Environmental
Protection Agency

April 18, 2011

**Re: Pandora Grain Supply, Pickaway County
General Storm Water Permit #4GC03372*AG**

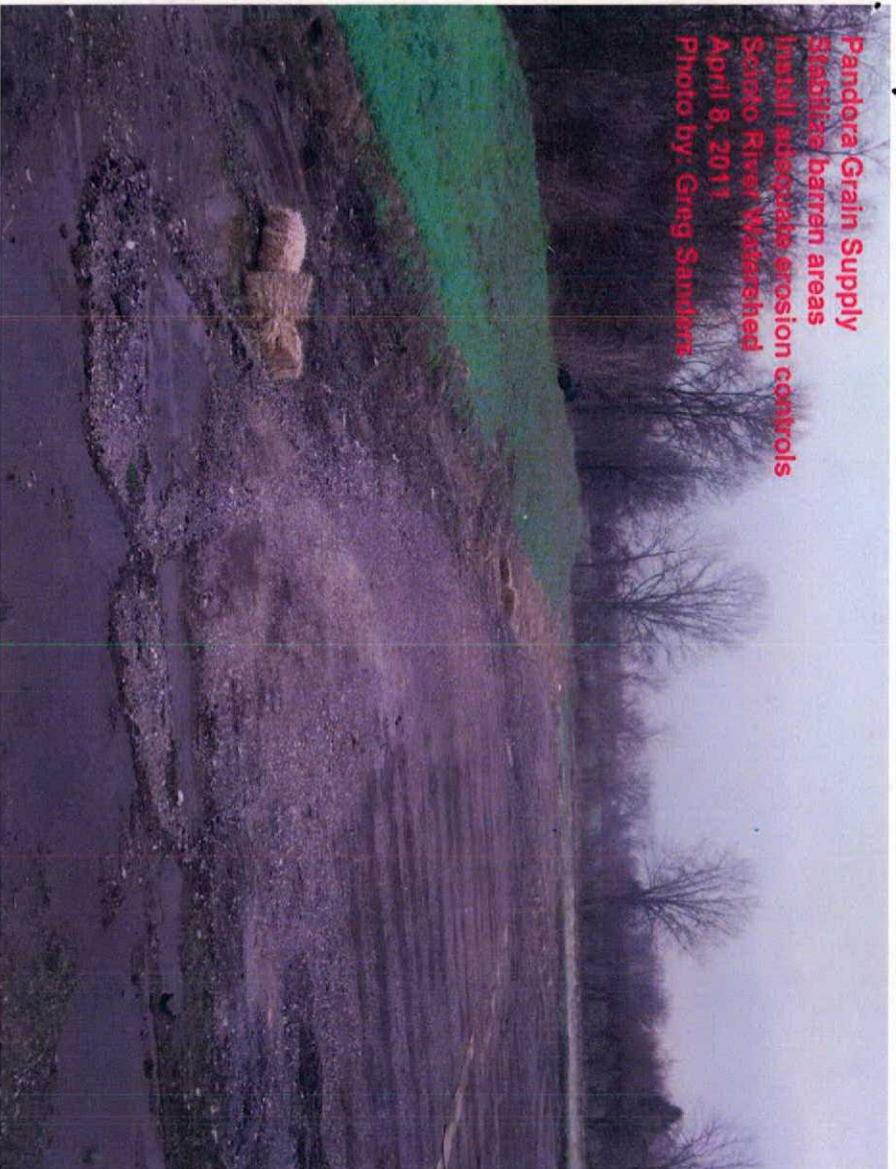
Pandora Grain Supply
Stabilize barren areas
Install adequate erosion controls
Sokoto River Watershed
April 8, 2011
Photo by: Greg Sanders

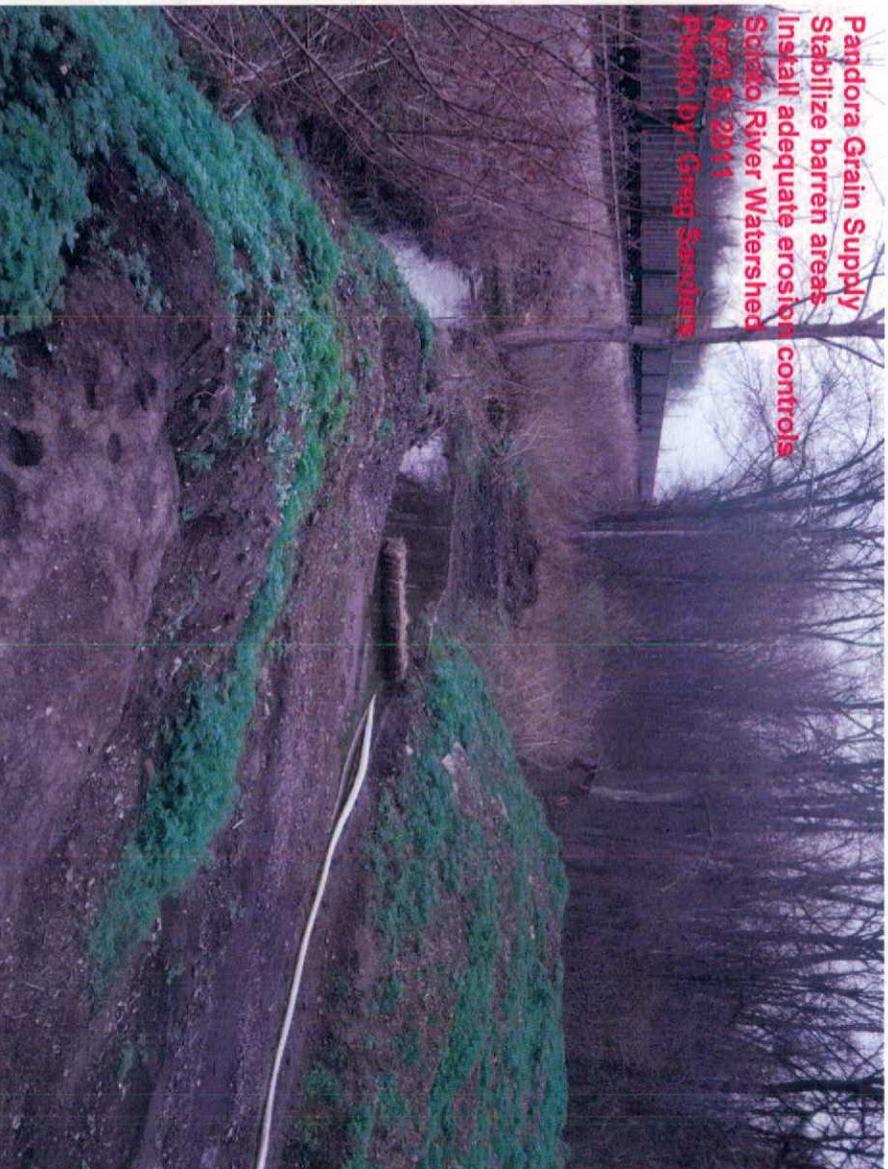
Pandora Grain Supply
Stabilize barren areas
Install adequate erosion controls
Sokoto River Watershed
April 8, 2011
Photo by: Greg Sanders
